February 24, 2023
HDR Project #10355449
Town of Newburgh Task Order 2022-11

Re: **Verizon Wireless**
Proposed New Wireless Telecommunications Facility – “Fostertown Road”
Pressler Road. Town of Newburgh, Orange County, NY

This technical memorandum (Tech Memo) was prepared to summarize HDR’s review of the application materials prepared by Young/Sommer (attorney for applicant) and submitted on behalf of the applicant, Verizon Wireless of the East LP d/b/a Verizon Wireless (Verizon, “applicant”) to construct a new wireless telecommunication facility at the above-referenced ±25.7-acre property (the site) located in “AR” (Agricultural Residence) and “RR” (Reservoir Residence) zoning districts in the Town of Newburgh (Town). Verizon has reported a need to supplement its local network’s capacity and coverage to provide enhanced and reliable wireless services to the site area. The applicant is seeking Planning Board approvals of a Special Use Permit and Site Plan, along with six waivers to the Town’s Wireless Telecommunication Facilities Code (Chapter 168). The need for set-back variances has not been identified by the applicant, based on the Bulk Table developed in the drawing set.

Driveway Plan View. Source: Construction Drawing Set Sheet C-1B Detail 1 dated 12-29-2022. Annotation added by HDR for clarifications.

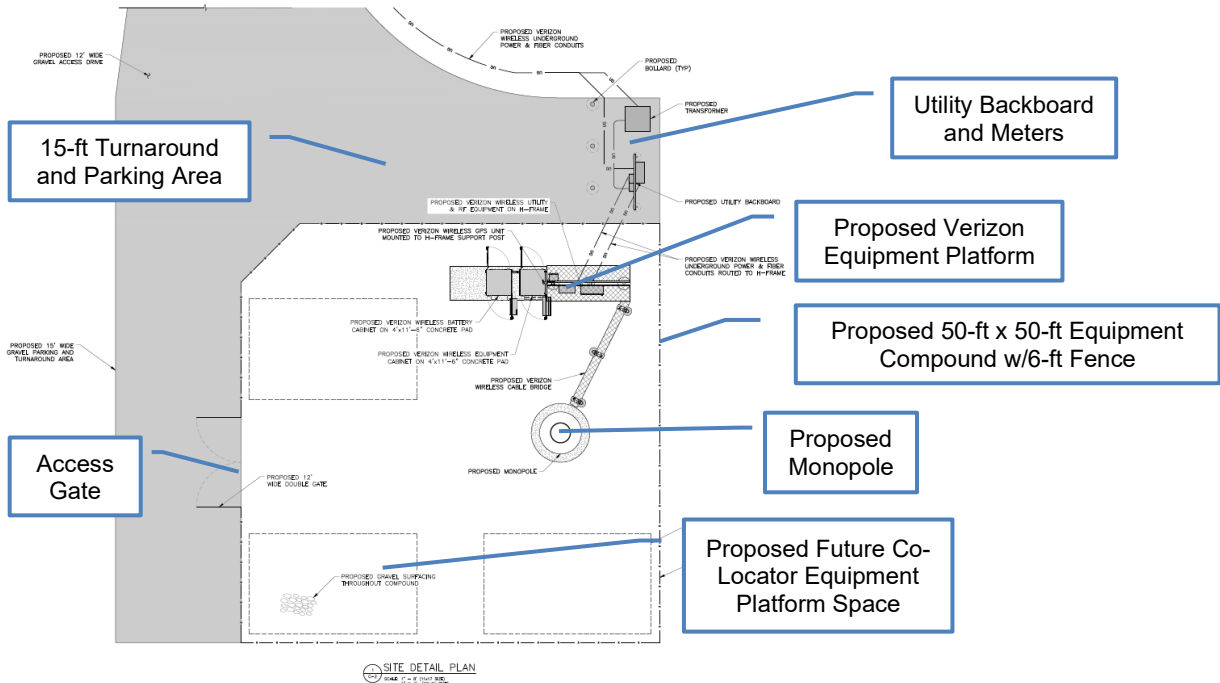
The proposed 12-ft wide gravel access road will require site grading and the removal of an approximately 40-ft portion of two separate existing stone walls and the clearing of an approximately 20-ft wide swath of vegetation located between two fields. The applicant did not include details on the number of trees or total area of clearing required to accommodate the access road. Verizon is proposing to install a 25-ft long 21-inch diameter corrugated HDPE culvert where the proposed access road crosses a topographic low spot, which is approximately co-located with the tree line that is proposed to be cleared. Overall, the topography is not expected to be altered significantly based on the access road profile and review of the survey map for the proposed tower/compound area. No changes to the existing stormwater flow regime at the site are anticipated, given the gravel surfaces and limited cut/fill proposed. No landscaping (e.g., vegetation to screen the ground-based compound) is proposed. No significant changes to the existing use of the land other than those already described are proposed. The total area of disturbance is listed as approximately 0.38 acres (inclusive of the equipment compound and the approximately 760-ft long access road).

- **The applicant provide better detail about the proposed tree removal at both locations where tree removal is proposed – at the curb cut on Pressler Road and at the stand of trees that borders the field where the tower is proposed.**

Site Detail Plan View. Source: Source: Construction Drawing Set Sheet C-2 Detail 1 dated 12-29-2022. Annotation added by HDR for clarifications.

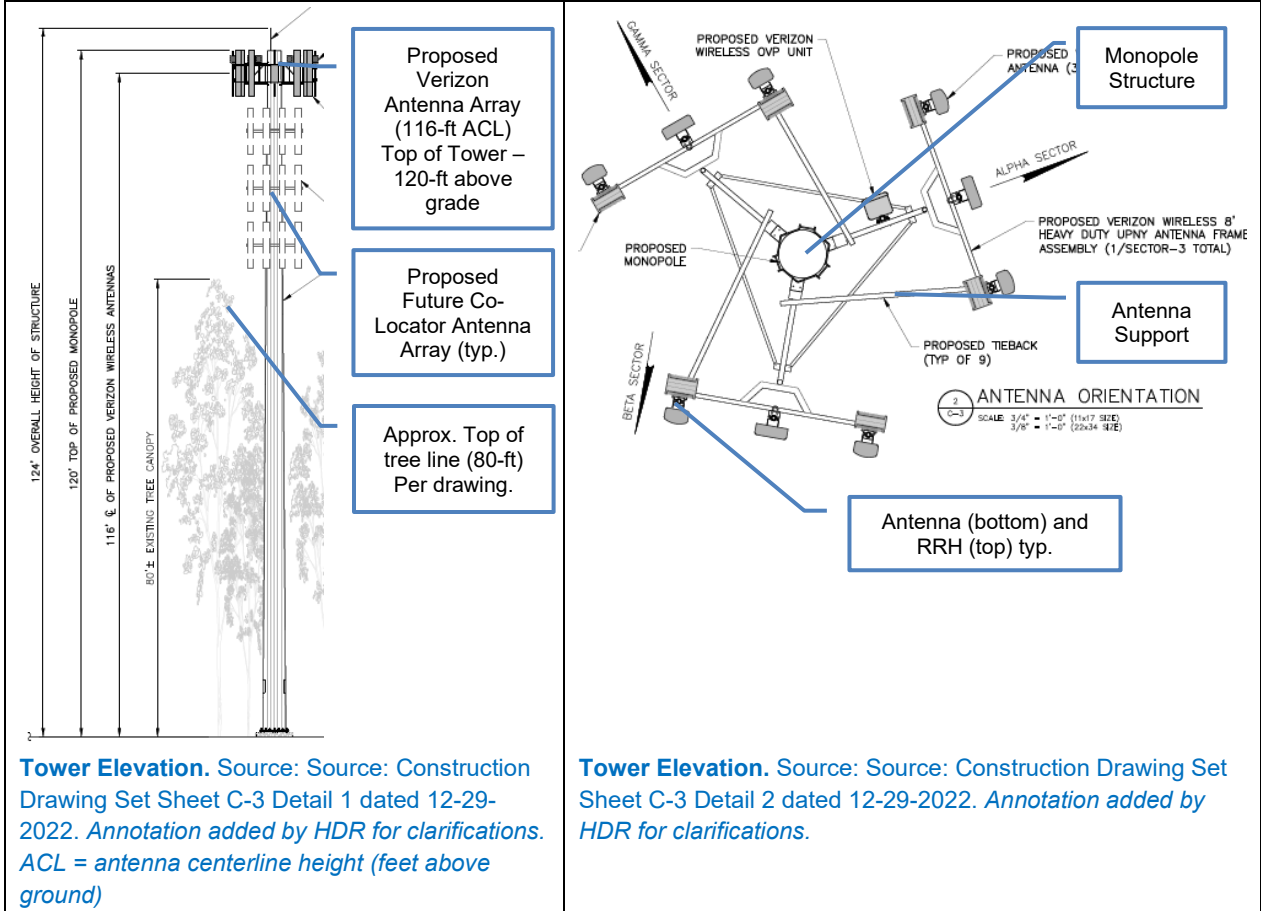
A 50 ft by 50 ft fenced compound (2,500 square feet total), underlain with $\frac{3}{4}$ " crushed stone (6" thick) and stabilization fabric, is proposed at the monopole base to provide dedicated room for the monopole, Verizon's ground-based equipment, and equipment of potential future co-locators. Access to the equipment compound will be from an approximately 760-ft long by 12-ft wide gravel access road that leads to the compound from a curb cut on the west side of Pressler Road (located in the Town of Plattekill, Ulster County). Existing soil will be removed as necessary at the equipment compound and along the access road. Installation of a 6 ft high chain link topped with 3 strands of galvanized steel barbed wire is currently proposed around the monopole and equipment compound area, encompassing the monopole structure and Verizon's equipment cabinets. It is noted here and expanded on in the Recommendations section at the end of this Tech Memo, that final colors, textures, materials of fencing will be at the Planning Board's discretion. Some ancillary equipment (i.e., electric meter and transformer) will be located outside of the fenced compound, as is typical at cell sites. A 12-foot wide double-gate is proposed for access at the west side of the fenced area. Small (maximum dimensions 18" x 12") RF notification and emergency contact signs (Verizon) are proposed on the compound fencing.

The proposed Verizon equipment and battery cabinets (1 each) will be installed on a new 4 ft wide by 11.5 ft long concrete pad. The electric panel, telco panel, and an OVP will be mounted on a 10 ft wide by 10 ft tall H-frame along with a 25W flood light. A single GPS antenna will be mounted just above the top of the H-frame. No tower lighting is required or proposed, and at-grade lighting will only be functional if required for night-time service visits. Cables connecting the antennas and other equipment located on the monopole with Verizon's ground-based equipment will be routed within the monopole structure. A 10-ft tall cable bridge that guides and connects cabling between the monopole and the ground-based equipment is also proposed within the fenced area.

FDV (Balmville Gamma Sector). Source: Applicant Filing.

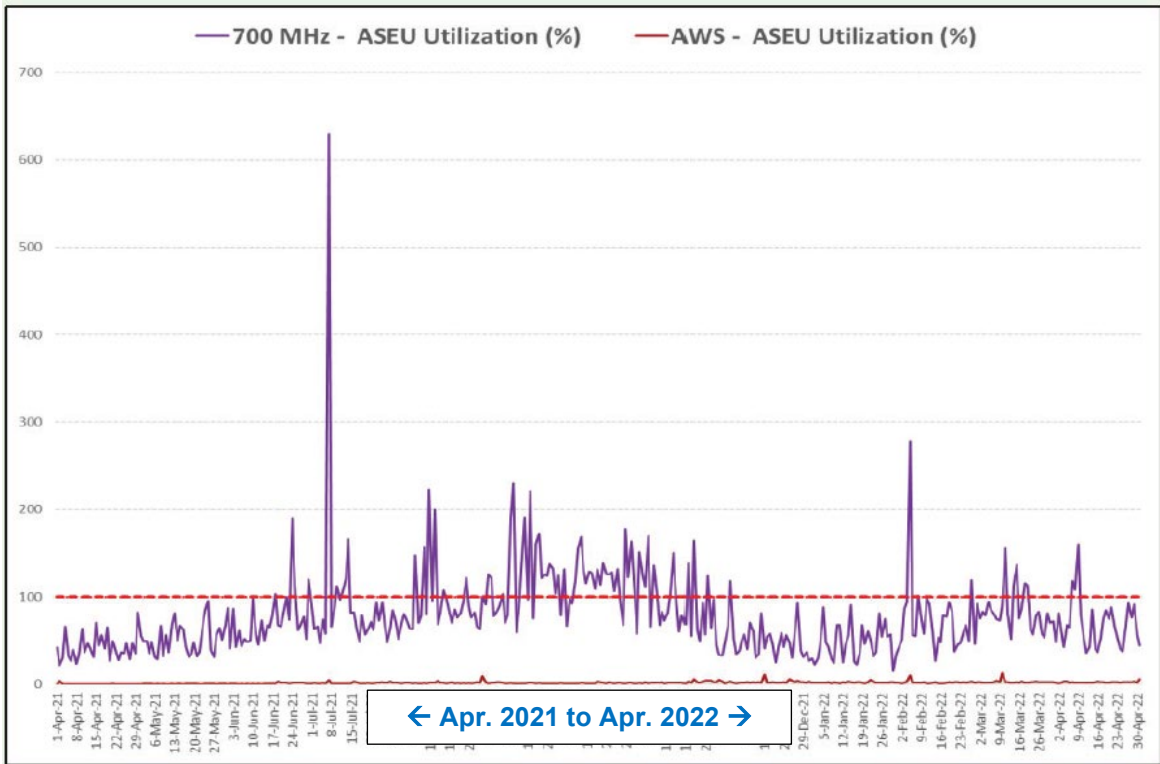
The capacity charts furnished by Verizon provide evidence that both the Bannerman View Drive and Quaker Street co-location sites are unable to consistently meet Verizon’s operational requirements with regard to FDV (both towers) and ASEU (Bannerman View Drive). The need for capacity relief appears most prominently in the charts for the Balmville gamma sector.

Low Band (700 MHz): current on-air signal strength (TOP) and proposed signal strength (BOTTOM).

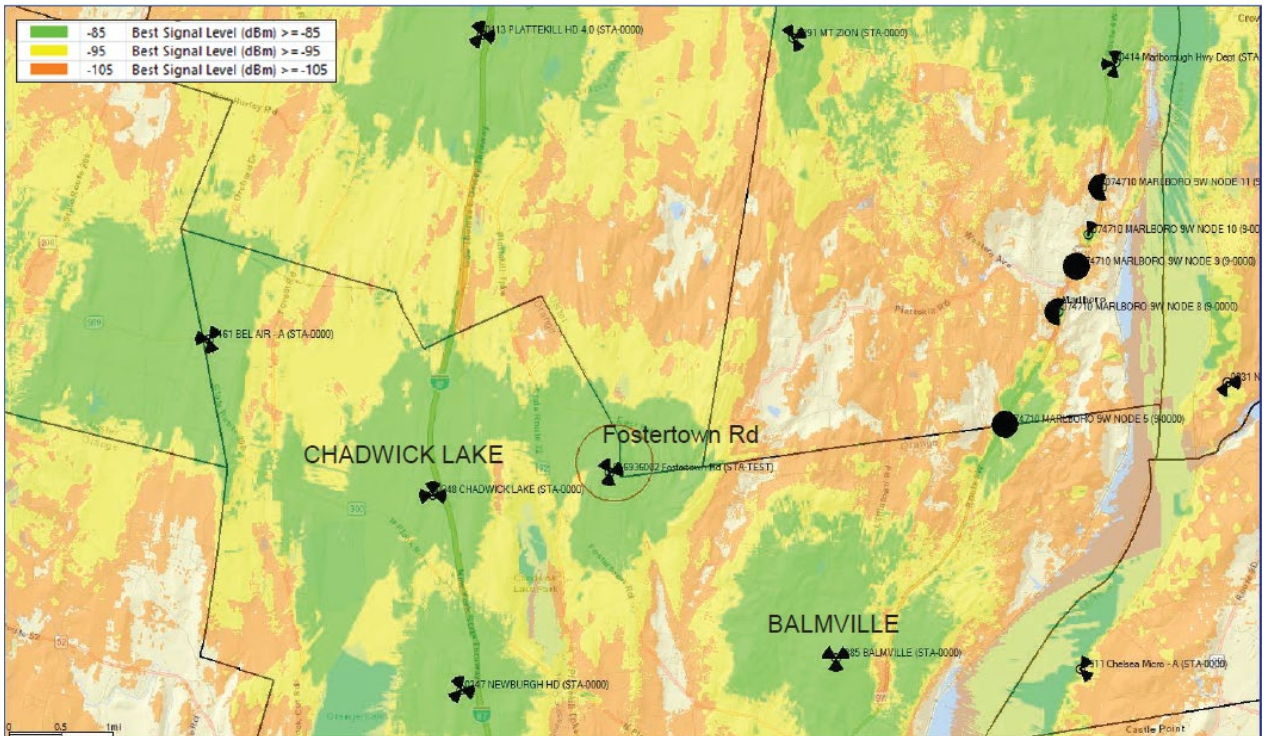
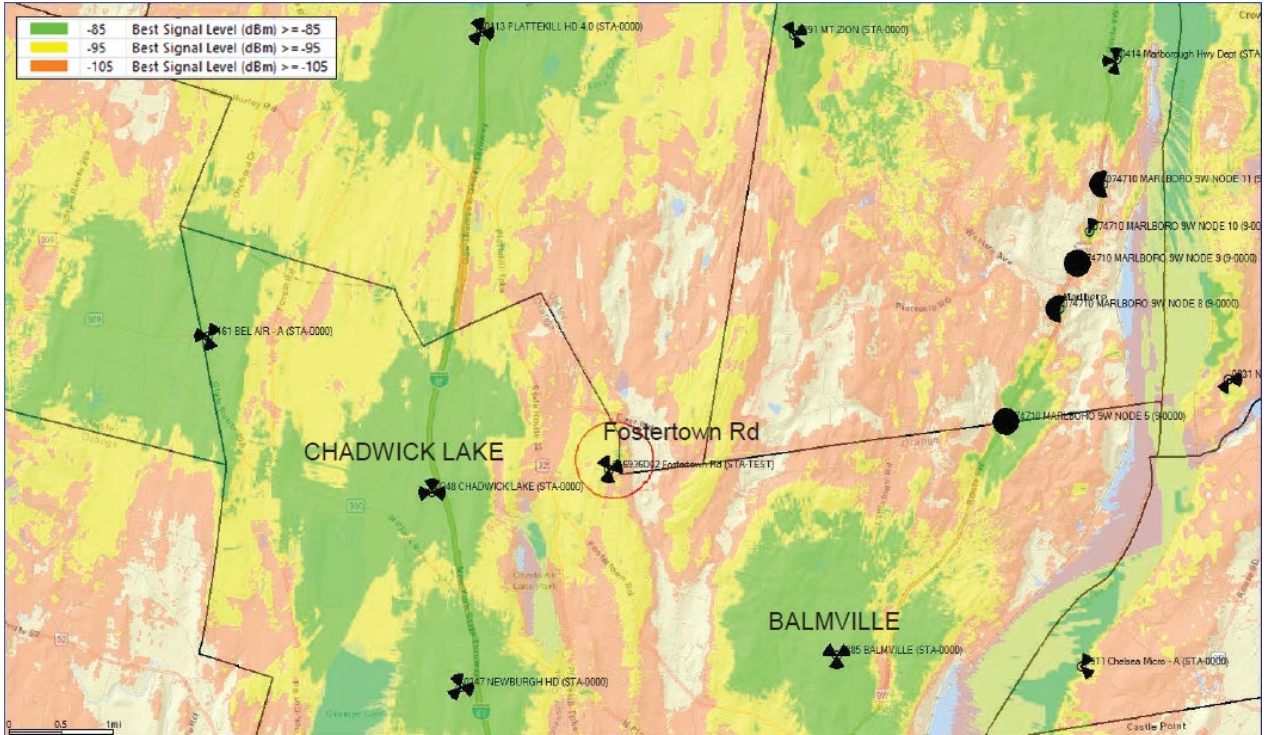
- A total of eight additional plots were provided. These plots show a similar, albeit smaller coverage footprint for both frequencies as would be expected from antennas mounted at a lower elevation. Though the coverage plots appear to be very similar, and potentially justify a shorter tower/lower antenna centerline, there would be deficiencies along Fostertown Road and East Road that would not satisfy Verizon's stated network improvement goals. Therefore, the proposed tower height appears to be reasonable and justified based on the coverage footprints shown.
